APPLICATION NO.	FILING DATE	FIRST NAMED INVENTOR	ATTORNEY DOCKET NO.	CONFIRMATION NO.	
09/966,439	09/28/2001	Frederic Danis	FR 000101	6375	
24737	7590 10/27/2003		EXAM	NER	
PHILIPS INTELLECTUAL PROPERTY & STANDARDS			AMINZAY, SHAIMA Q		
P.O. BOX 30 BRIARCLIF	F MANOR, NY 10510		ART UNIT PAPER NUMBER		
	,		2674	8	
			DATE MAILED: 10/27/2003

Detailed Action

ii. P/O Figure 4

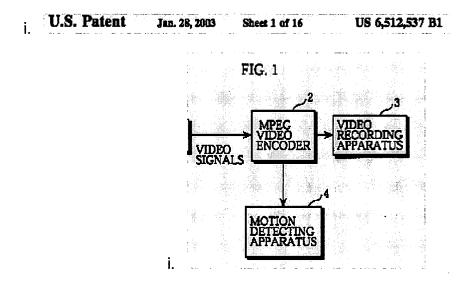
- However Shimizu et al. teaches the motion detection using the motion vector on a flat or non-flat surface (column 4, lines 3-19) which are calculated by the video decoder and conformity of the video decoding, and or encoding with the MPEG standard (Abstract; column 1, lines 1-20 and 41-56; part of figures 1 and 4 below). Shimizu et al. does not expressly show that the motion vector is parallel to the image. However, he shows that the vector can be on a flat area (flat plane). This clearly suggests that since the vector is in a flat plane and the image is in flat plane then the vector is parallel to the plane.
